PRELIMINARY DRAINAGE REPORT

FALCON MEADOWS AT BENT GRASS

Galloway responses

PUDSP-20-005

Project: **Falcon Meadows at Bent Grass**Inlet ID: **DP 8 - Existing Sump Inlet (BG Filing No. 2)****Gutter Geometry (Enter data in the blue cells)**

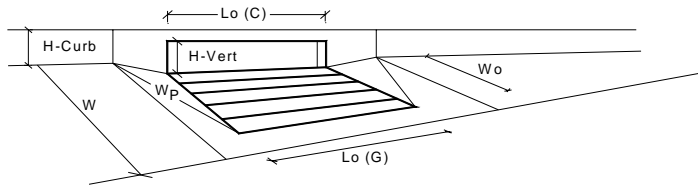
>60 cfs?
from DPs
15, 12, 5,
4, E1, E2,
C4

DP 8 has been
updated to include
flowby from DP 12
and DP 15.

Falcon Meadows at Bent Grass
DP 11 - Type D Area Inlet (Relocated)

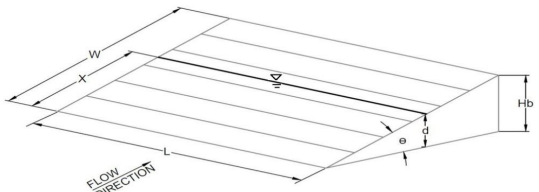
Warning 04: Froude No. exceeds USDCM Volume I recommendation.

See question on plan

See response on
drainage map

Project: **Falcon Meadows at Bent Grass**Inlet ID: **DP 24 - Existing At Grade Inlet (BG Filing No. 2)****Gutter Geometry (Enter data in the blue cells)**

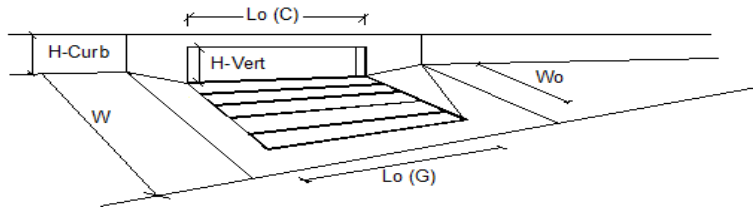
>40 cfs from DP 14 and
DP 16 - 24 cfs = 16 cfs?

Routing has been updated to
have flowby from DP 14 and 16
to go to DP24. Spreadsheet has
been updated with revised flow
